Technical Service Bulletin

14-01-055

ELANTRA (MD)

SUBJECT: SUNROOF DEFLECTOR REPLACEMENT
(SERVICE CAMPAIGN TV6)

Part Name	Part Number
Sunroof Deflector Assembly	 A photograph of a long, white, cylindrical sunroof deflector assembly with black end caps and small metal tabs at each end, resting on a wooden surface.
Sunroof Deflector Assembly	81641-3X000QQH

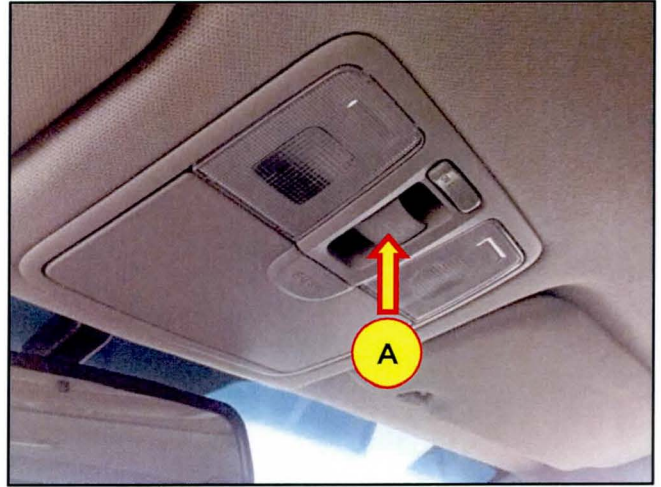
Description: On some 2015 ELANTRA (MD) vehicles, a rattle noise from the sunroof deflector may be heard while driving. This bulletin provides the procedure to replace the deflector with a revised deflector spring.

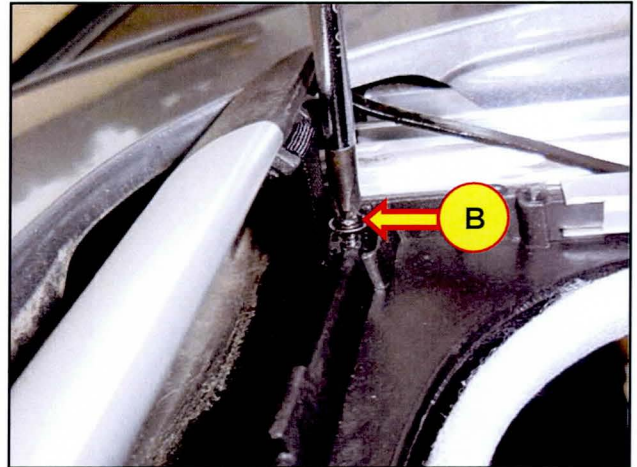
2. Remove the deflector mounting screw (B) on both sides.

3. Remove the sunroof deflector (C) from the vehicle and then install the newly improved one in reverse order of removal.
